OFFICE OF NEW REACTORS
SUMMARY FEEDBACK ON FOUR KEY LICENSING ISSUES
NEXT GENERATION NUCLEAR PLANT
PROJECT 0748

The remainder of this NRC staff document summarizes and consolidates the staff's views in terms of the July 6th letter's specific requests for feedback under each of the four key issue headings. Specifically, this document provides staff feedback under bulleted subheadings that quote or paraphrase the specific requests from the July 6th letter. More detailed NRC staff comments on these and related issues are provided in the following two updated white paper assessment reports, which are being issued concurrently with this document:

Figure 1. NGNP Frequency-Consequence curve proposed by DOE/INL (ML12262A090).

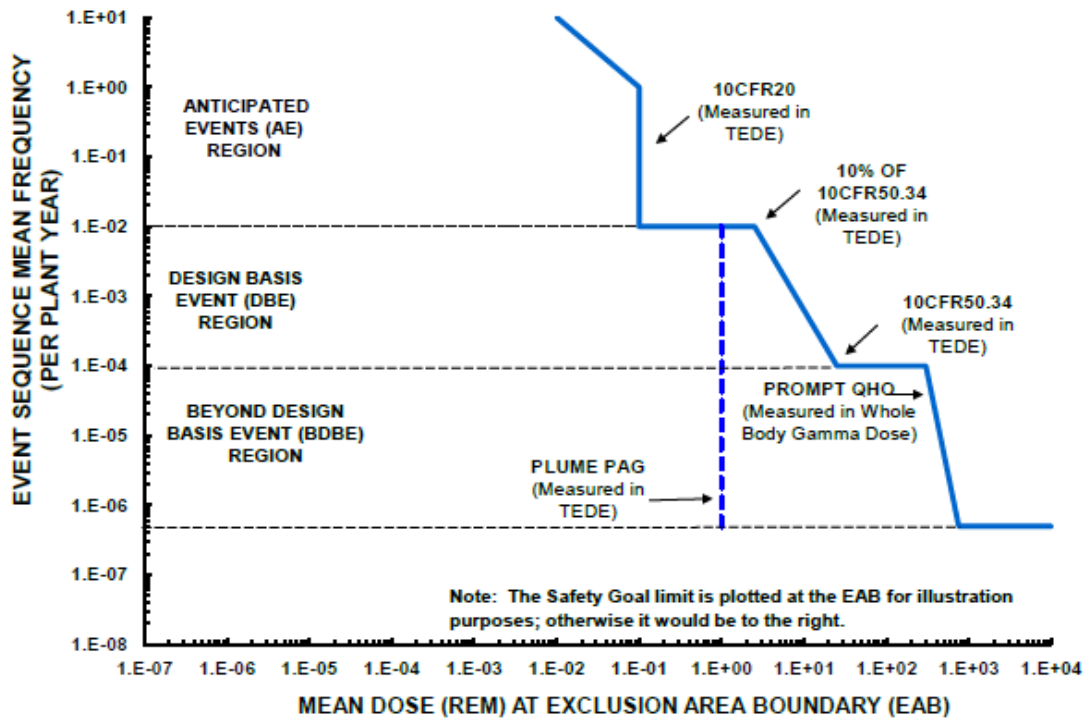
The NRC staff concludes that the proposed approach to placing top level regulatory criteria (TLRC) on a frequency-consequence (F-C) curve is reasonable. Figure 1, a copy of DOE/INL's proposed F-C curve, identifies the regulatory bases for the respective TLRC and displays the TLRC-based dose limits as a function of event sequence mean frequency per plant-year over the proposed event category regions.

The proposed FC-curve's event category regions and their respective TLRC bases are summarized as follows:

- The TLRC for the AE region would be based on limiting the cumulative annual dose to an individual member of the public to 100 millirem total effective dose equivalent (TEDE) as required in 10 CFR Part 20, "Standards for Protection against Radiation." DOE/INL proposes that AE source terms should be mechanistically modeled and that dose consequences should be realistically calculated at the exclusion area boundary (EAB).
- The TLRC for the DBE region would be based on an event-based public dose criterion of 25 rem TEDE as required in 10 CFR 50.34, "Contents of Applications; Technical Information."⁷ DOE/INL proposes that DBE source terms should be mechanistically modeled and that dose consequences per event sequence should be conservatively calculated at the EAB.

- The TLRC for the BDBE region would be based on cumulative public dose limits derived from the quantitative health objectives (QHOs) of the NRC safety goals, whereby the QHO for prompt fatality is the most limiting. DOE/INL proposes that BDBE source terms should be mechanistically modeled and that offsite dose consequences should be realistically calculated.

The TLRC are used with the F-C curve to establish limits on the frequencies of event sequences and their radiological consequences. The F-C curve and its TLRC are then used in the categorization and evaluation of LBEs and in characterizing the treatment of SSCs. The overall approach provides a logical technical basis for ensuring and demonstrating that the design meets applicable regulatory criteria for public health and safety. It further bears noting that this approach is largely consistent with the staff's approved recommendation in SECY-03-0047 regarding Issue 4 in that it places greater emphasis on the use of risk information by allowing a probabilistic approach in the identification of events to be considered in the design and licensing.
